RE: US 181 Harbor Bridge Replacement Project
CSJ# 0101-06-095
Notice of Nonconforming Work

**INDEPENDENT STRUCTURAL ANALYSIS FOR THE CORPUS
CHRISTI NEW HARBOR BRIDGE PROJECT**

**Phase 2 Part 1 REPORT – CABLE-STAYED MAIN BRIDGE
SUMMARY DOCUMENT**

Figure 2: Summary of Service Axial Compression and D/C Ratios for 1NT/1ST Drilled Shafts – Drilled Shaft Layout Schematic Provided by Others

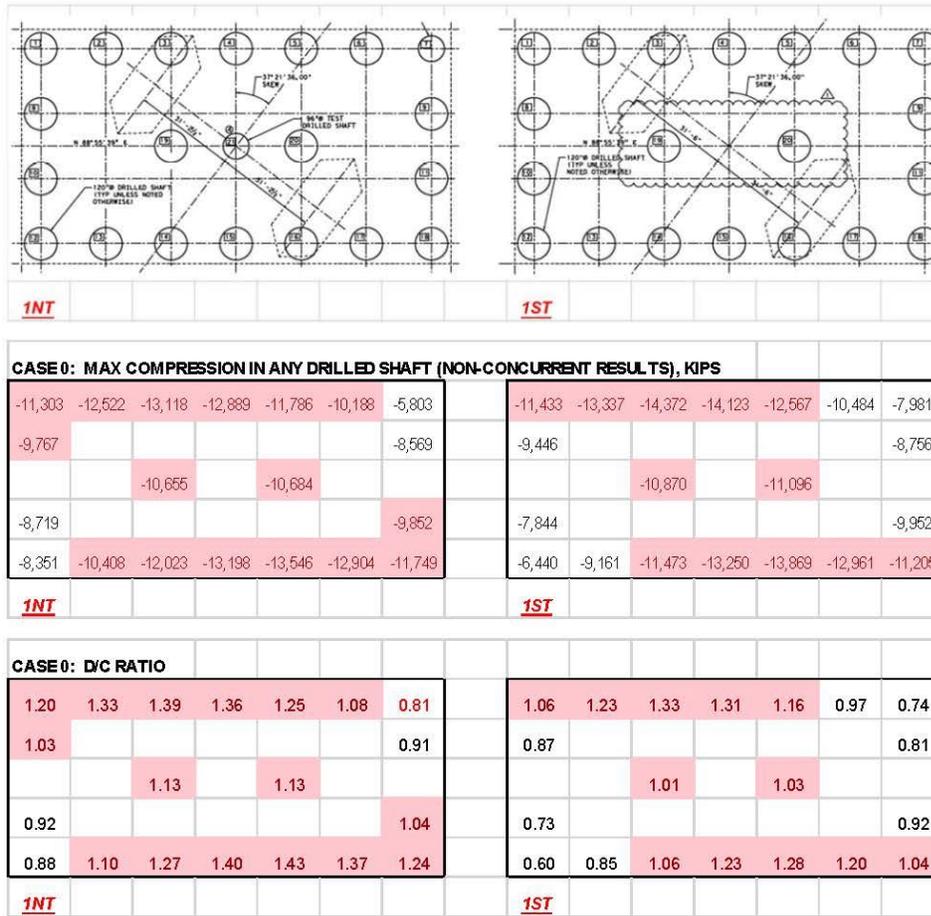
At foundation 1NT, 16 of the 20 drilled shafts are deficient for Service and for Strength and Extreme load combinations. At foundation 1ST, 12 of 20 drilled shafts are deficient under Service loads and 10 of 20 are deficient under Strength and Extreme load combinations. Figures 2 and 3 below show the maximum compression observed in each drilled shaft along with D/C ratios for each shaft for Service, Strength, and Extreme load combinations.

Figure 4: Summary of Maximum Axial Load - Flexural D/C Ratios for the 1NT and 1ST Drilled Shafts – Drilled Shaft Layout Schematic Provided by Others

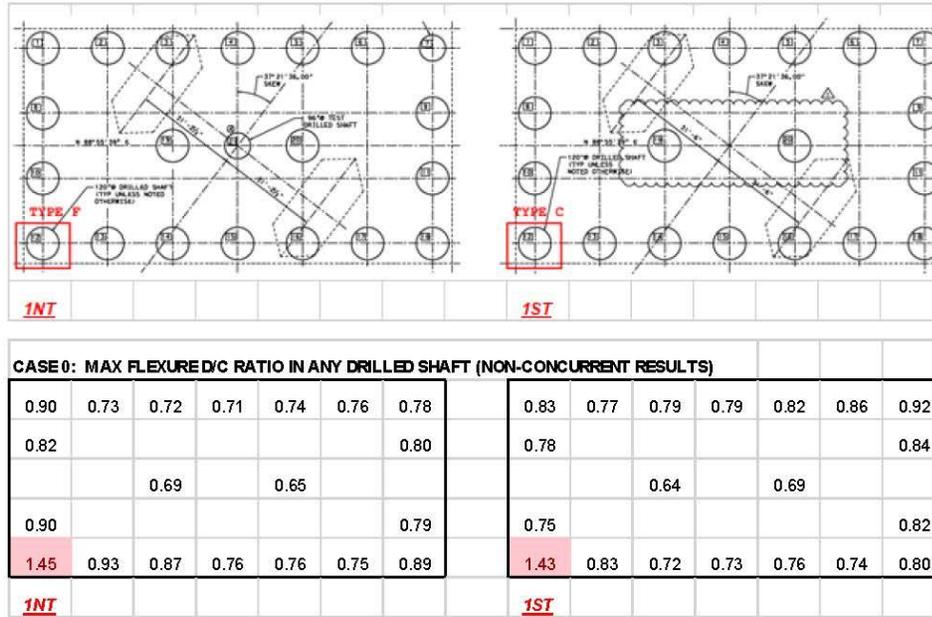
One drilled shaft at Tower 1NT and one drilled shaft at Tower 1ST do not meet the project requirements for combined axial load / flexural resistance per AASHTO LRFD §5.7.4.5. This occurs under combinations that result in tension in corner drilled shafts. Figure 4 below provides a summary of locations and D/C ratios associated with this finding.

Figure 5: Plot of Drilled Shaft Axial Load - Flexural D/C Ratios Over Depth of Drilled Shafts

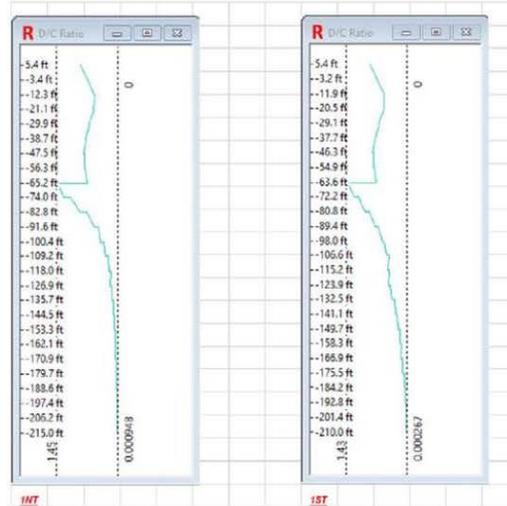
The capacity at critical sections are reduced due to shallow termination of longitudinal reinforcement in the shaft. Noting that the deficient drilled shafts are at tension locations, Figure 5 below shows that the demand-to-capacity is critical at a lower position in the shaft (~64 ft) where the reinforcement is discontinued at a depth that is too shallow, given the demands in these two drilled shafts at those depths.

Figure 6: Summary of Minimum Transverse Reinforcement C/D Ratios for Drilled Shafts – Drilled Shaft Layout Schematic Provided by Others

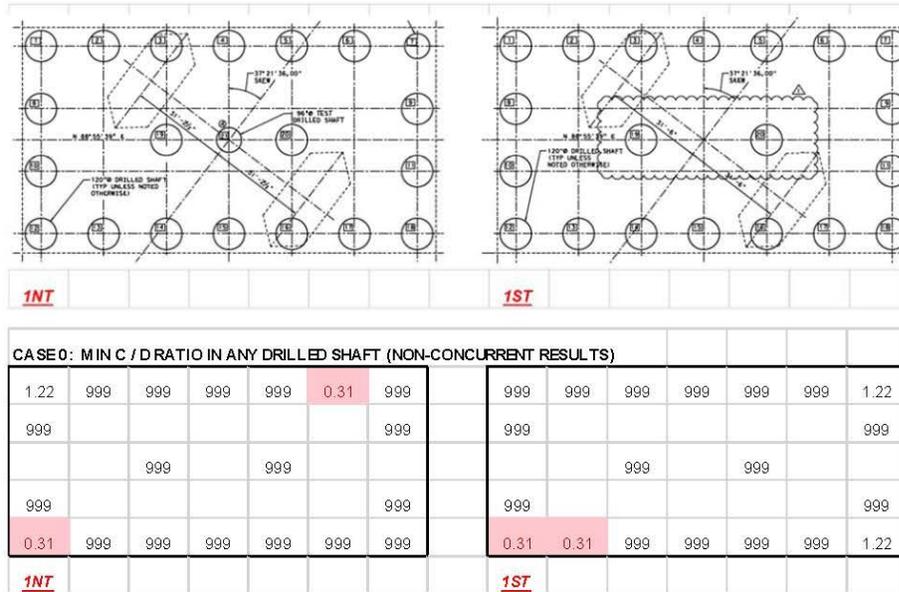
Verification was conducted along the entire depth of the drilled shafts (i.e. from top to bottom). The minimum transverse reinforcement C / D ratio in each of the drilled shafts is presented in Figure 6 below for both 1NT and 1ST:

Note that a C / D ratio of 999 presented in Figure 6 above indicates that the shear demand is less than one-half the factored concrete shear capacity, and therefore transverse reinforcement is not required as per AASHTO §5.8.2.4 at this location.

Figure 7: Maximum Longitudinal Reinforcement Stress and Equivalent D/C Ratios for Control of Cracking by Distribution of Reinforcement – Drilled Shaft Layout Schematic Provided by Others

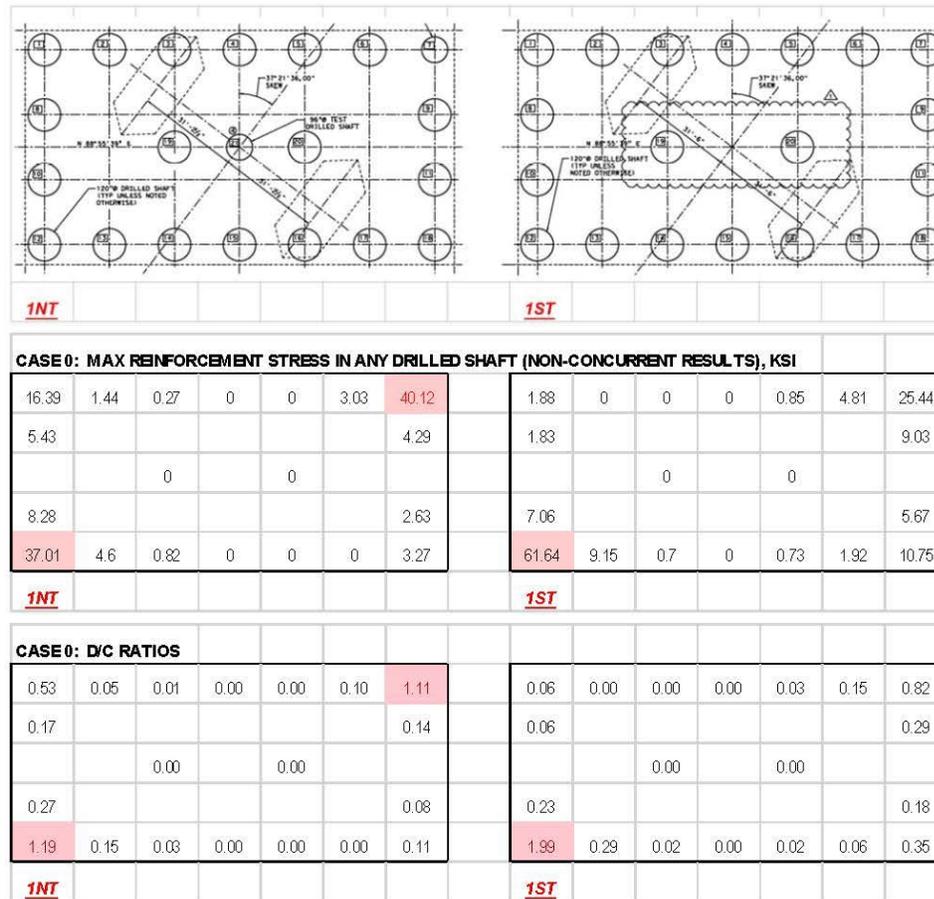
The maximum reinforcement stress demand in each of the tower drilled shafts and the corresponding equivalent D/C ratios are presented in Figure 7 below for both 1NT and 1ST:

Figure 17: Foundation Cap 1NT and 1ST, Summary of Transverse Checks at Section 2

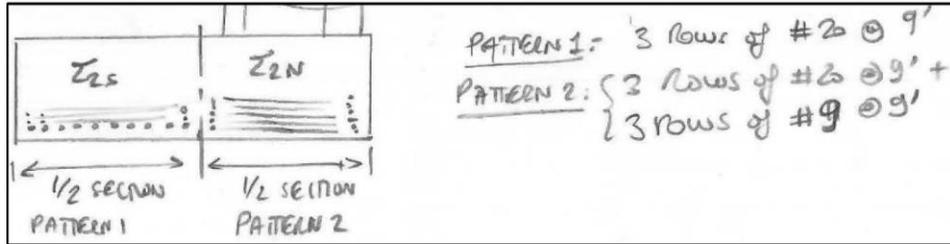
The Section 2 check is shown below, which is similar to Section 4 but with greater demand. Therefore, the check at Section 2 suffices as a check for both sections.

Σ2 Axial + Bending – Strength Limit state – Result Summary		
Section	Governing LC	Max D/C ratio
Σ2 North	2	1.05 → DEFICIENT
Σ2 South	10	0.33 → OK
Σ2 total	2	0.67 → OK

Figure 18: Foundation Cap 1NT and 1ST, Insufficient Reinforcement Development at Section 2

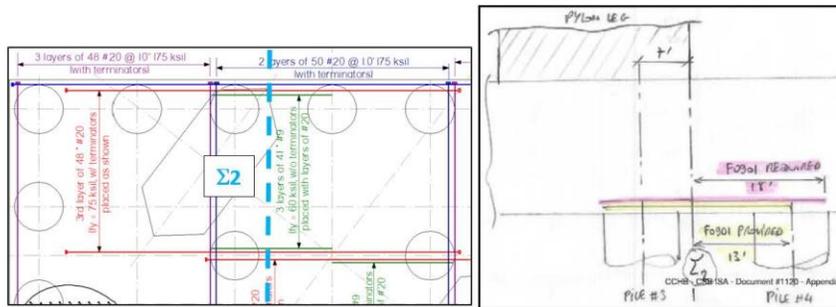
The reinforcement development length of the pile cap at Section 2 was calculated and found to be deficient per AASHTO LRFD §5.11.1.2.

Figure 23: Sketch Showing Concentrated Reaction from Tower Leg at the Edge of the Foundation Cap

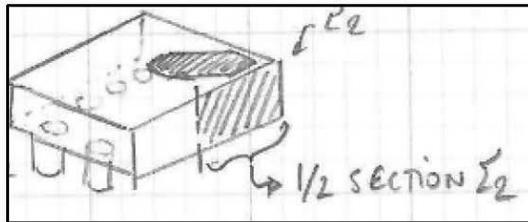
As observed with the flexural demands in the foundation cap, the shear loads are highly concentrated adjacent to the tower legs. For conventional designs, AASHTO may allow for the full-section width to be considered as part of the capacity, but that generally applies to a concentrically loaded cap without pronounced edge loadings, which is not the case for the foundation caps at Towers 1NT and 1ST. Therefore, both full- and half-sections are checked for one-way shear.

Figure 26: Shear Stresses at Critical Foundation Cap Sections Around the Tower Leg Perimeter under Maximum Loading – Side A-F Represents the Edge of the Cap

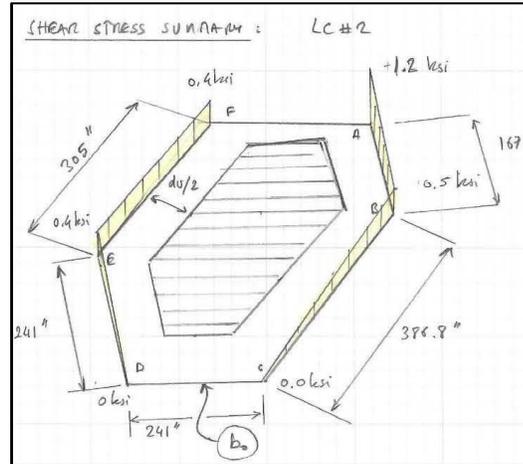
The loading pattern shows very high shear stress concentrations next to the edge of the foundation cap. The load resistance capability of the foundation cap is limited by having the leg so close to the edge. This prevents the distribution of the shear resistance to a “full” perimeter around the base of the leg.

Figure 30: Brick Model Results at Two-Way Action Plane at Foundation Cap 1ST

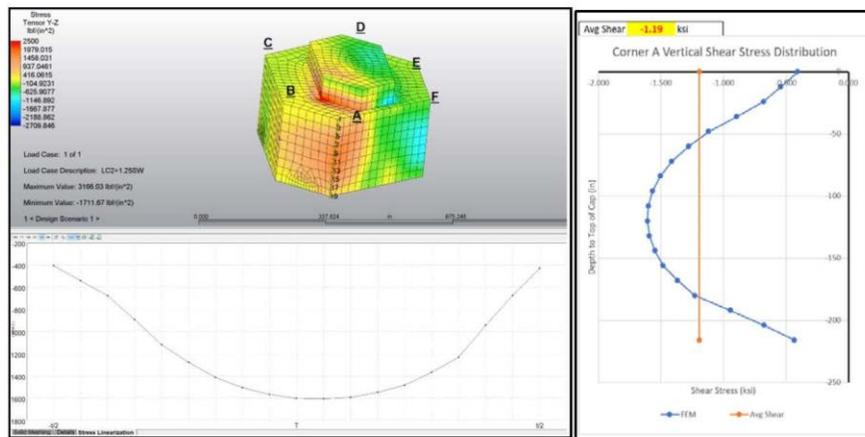
The brick element model was able to provide the shear stress variation through the depth of the foundations cap. For comparison, the average shear stress over the depth of the cap at Corner A (the location of the greatest shear stresses) was computed to be 1.19 ksi, which closely agrees with the 1.20 ksi shear stress observed in the thick plate model at this location. Based on this, it can be concluded the thick plate model results were sufficient in identifying the deficiencies stated above. However, the brick element model revealed that the maximum shear stress at mid-depth of the foundation cap at Corner A exceeds 1.5 ksi, which is more than 25% greater than the average shear stress considered by the thick-plate element model used to identify the two-way action deficiency stated above.

Figure 31: NB Service 1 top compressive stress

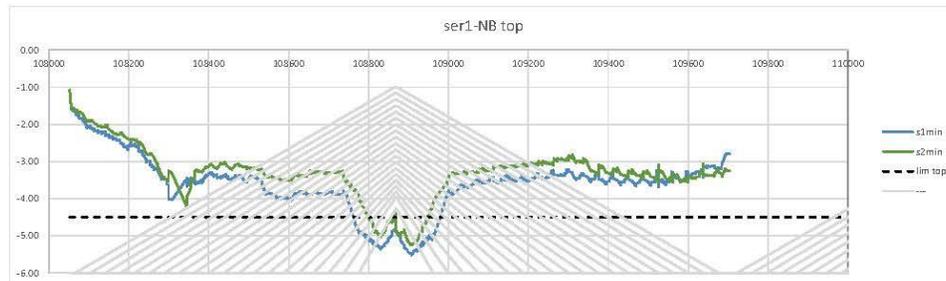
It is possible that the top slab compression and positive (sagging) moment could be reduced with a refined third-stage stressing. However, this is not provided in detail in the erection document 277609-NHB-MAN-MEM-01.

Figure 33: NB shown, 5 PT bars in bottom slab in the first 23 segments adjacent to the pylon – Schematic by Others

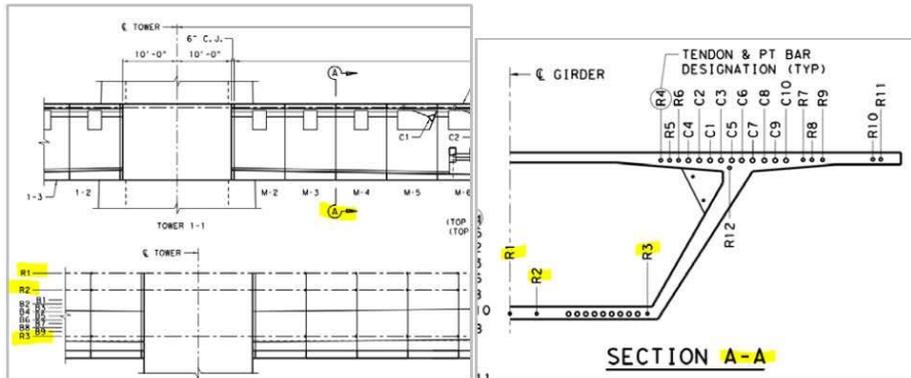
It is possible that the sagging moment could be reduced with a refined third stage stressing. However, this is not provided in detail in the erection document 277609-NHB-MAN-MEM-01.

Another possibility is that the bottom post-tensioning could be increased in the segments adjacent to the pylon where the PT quantity seems inadequate. For example, there are only 5 - 1 ¼” PT bars in the bottom slab of the northbound box girder (similar for southbound).

Figure 35: Sketch of bottom block connection between the delta frame and box girder

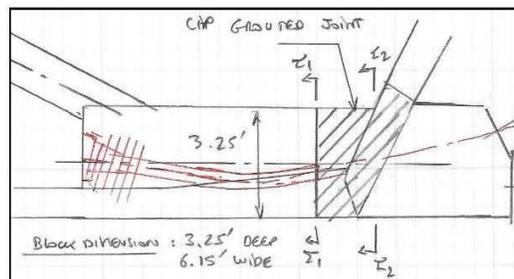
The ISA team evaluated the demand on the connection between the delta frame and the precast block located at the bottom inside corner of the box girder and the cast-in-place grouted pour, shown as Section $\Sigma 1$ in Figure 35 below. The shaded region, critical to the transfer of loading from the box girder to the delta frame and supporting stay cables, is unreinforced, with the exception of the two tendons located roughly at the center of its section. ISA model results indicate that this section is subjected to both axial and bending demand, leading to tension at the top fiber of the precast block and the unreinforced region of the connection. Moreover, this joint must transfer shear across the unreinforced joint.

The top fiber of the unreinforced cast-in-place (CIP) grouted connection between the base of the box girders (both Northbound and Southbound) and the bottom node of the delta frame is subjected to tension under both unfactored permanent loading and the Service I load combination, exceeding the no-tension requirement for joints without bonded reinforcement mandated by AASHTO LRFD §5.9.4.2.2.

Figure 36: shear key reinforcement and location of tendon local anchorage zone

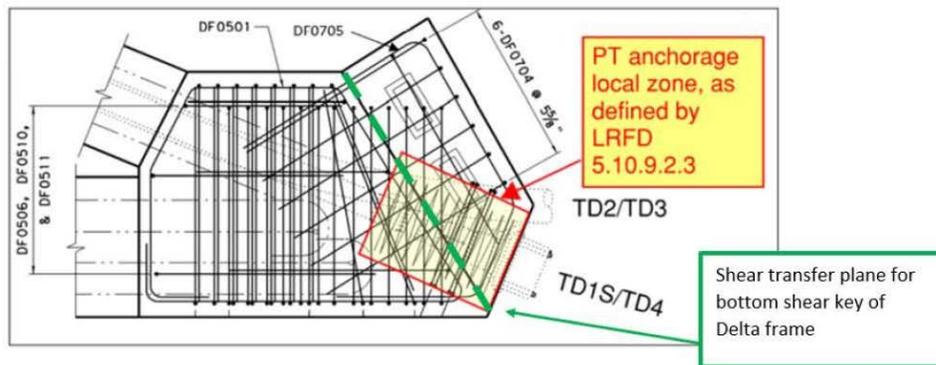
The anchorage and the local confinement reinforcement (spirals) of the tendons TD1S and TD4 are located next to the delta frame shear key. This is a very unusual and unconventional detail, as the anchorages create a highly disturbed state of stress at a critical interface. The shear key transfer plane is

located within the local zone of the PT anchorage, as defined by AASHTO LRFD §5.10.9.2.3, where large localized tensile stresses are expected and where reinforcement congestion is considerable, as shown in Figure 36 below. The reduction in this shear plane's capacity due to the presence of these tendon anchorages is unknown, since no provision exists within AASHTO LRFD to account for this configuration. As such, the ISA team cannot validate that the shear key as designed meets the AASHTO LRFD specifications.

Figure 39: Backspan Piers with Tension in Piles – Pile Layout Schematic Provided by Others

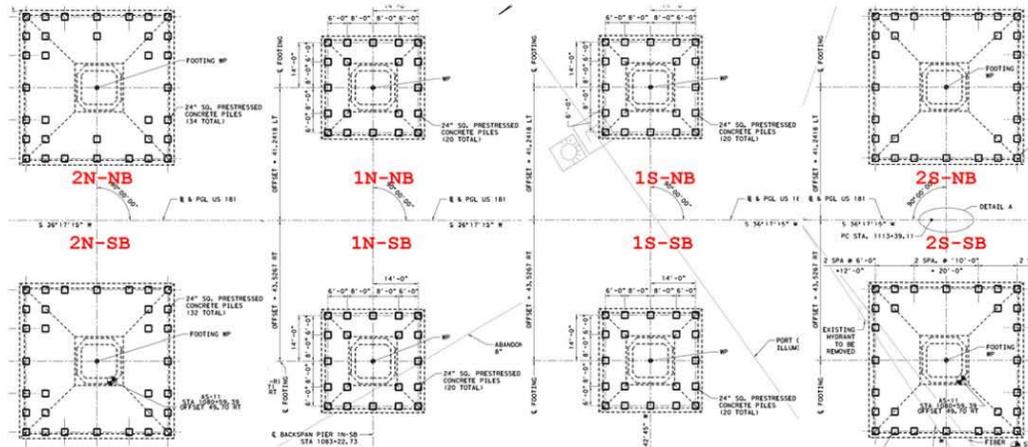
The maximum tension in each of the driven piles under the Service I load combination is presented below for backspan Piers 1N/S and transition Piers 2N/S:

Figure 40: Passive Strand Development in Pier Foundation 1N, 1S, 2N, and 2S – Detail Provided by Others

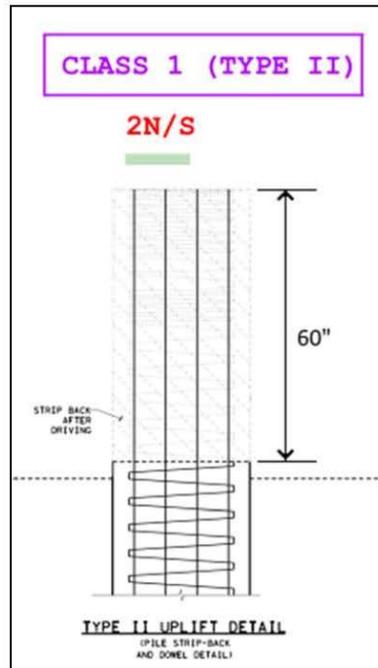
The driven piles at Pier Foundations 1N, 1S, 2N, and 2S are connected to the pile cap using a modification of the “strip-back detail” shown on the TxDOT Prestressed Concrete Piling (CP) drawing. The upper 60 inches of the strands that were initially bonded in the pretensioned driven piles are exposed by this “strip-back” procedure.

For the “Class 1, Type II” and “Class 2 Type II” piles, the original design and the current drawings specify a passive strand development length of 60 inches, extending above the top of the stripped back pile. Calculations for passive strand development into the pile cap are not specified by AASHTO LRFD, and very little research on this topic exists. The design check of piles under tension (if tension is permitted, see related Finding #26) is dependent on the development of these passive strand, and therefore cannot be verified.

Figure 41: Indirect Load Path of Vertical Ties Transferring Pile Tension

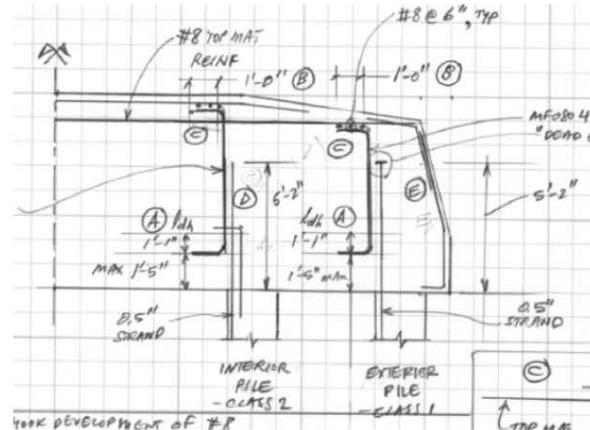
- In Pier 1N and 1S, the #6 dowel bars are post-installed with adhesive into the stripped back pile. Due to the proximity of these bars to the pile face, the expectation of cracked concrete, and the dowel spacing, the resistance of these dowels is significantly less than that of cast-in reinforcement bars. Any contribution of these dowel bars to transferring uplift pile capacity is insignificant and should be neglected.

Figure 42: Gaps in Pile Cap Bottom Surface Reinforcement in Between Piles

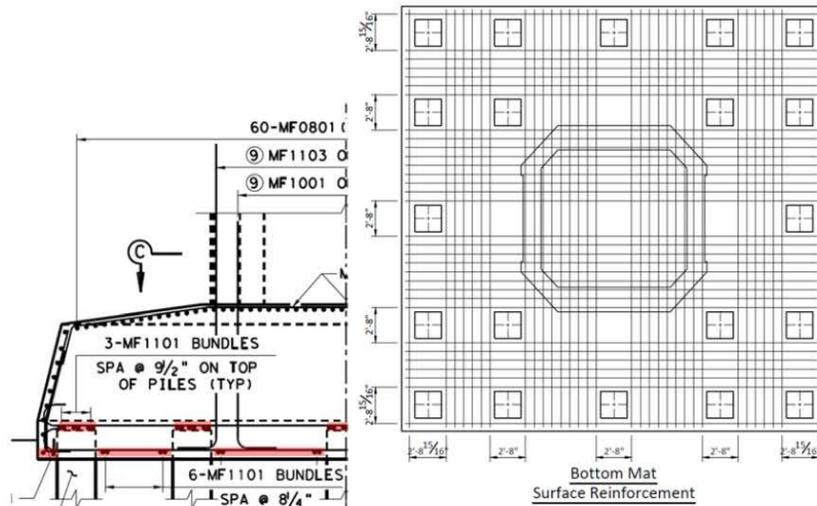
- In Piers 1N, 1S, 2N, and 2S, the pile cap bottom mat reinforcement bars exceed the maximum spacing requirement of 18 inches in the zones between piles, per AASHTO LRFD §5.10.3.2; see Figure 42 below.

Figure 43: Top slab Service tension check

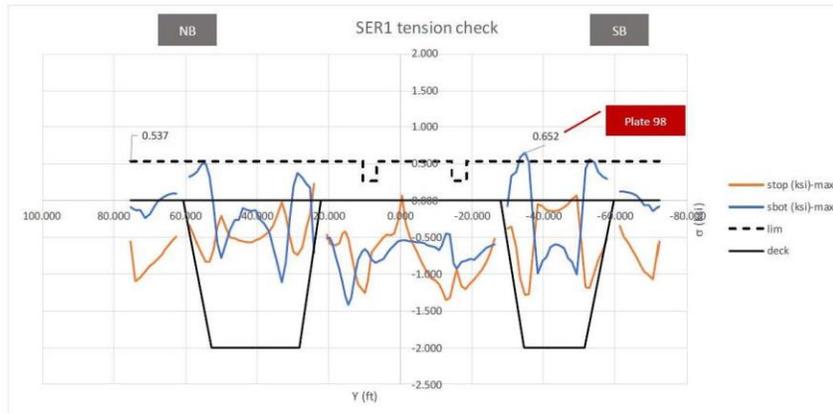
The bottom fiber stresses in the southbound box girder at the top slab haunch exceed the allowable stress limits of AASHTO LRFD Table 5.9.4.2.2-1 under Service load combinations, as show in Figure 43 below.

Figure 45: Top slab incremental stresses for stay stressing S26 (the grid is 10 ft by 10 ft)

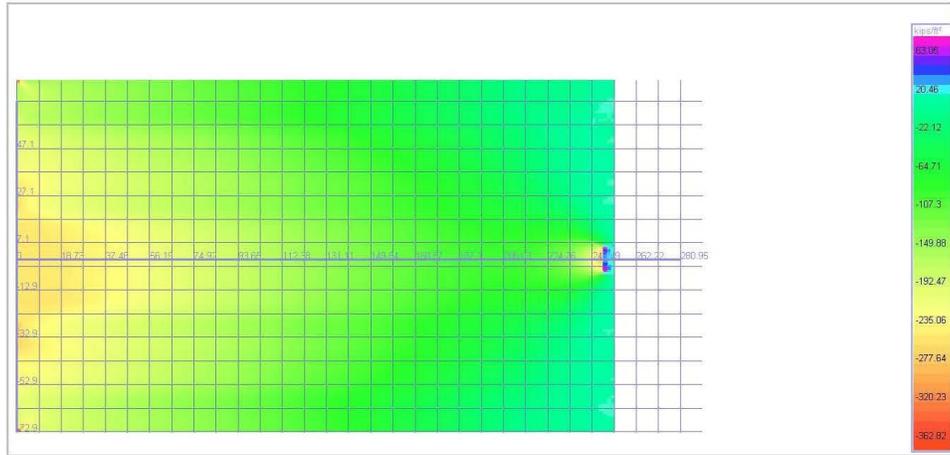
When looking at the compressive incremental stresses in top slab due to Stay S26 stressing, Figure 45 below shows that diffusion is only complete at approximately 70 ft in front of the stay forces.

Figure 46: Web principal tensile stresses at Segment 7 when stressing the S26 stay cables

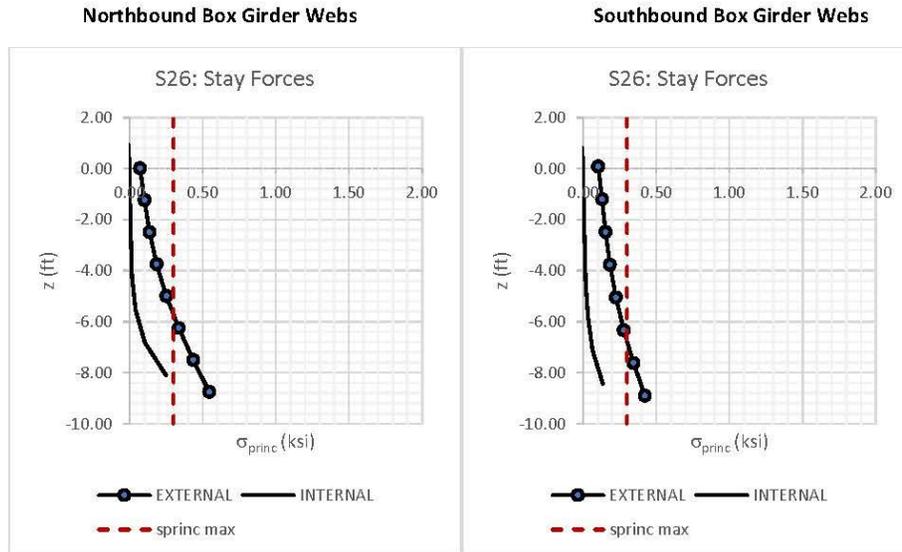
The left-hand graph in Figure 46 below shows principal tensile stresses in the webs for the northbound box girder and the right-hand graph shows principal tensile stresses in the webs for the southbound box girder.
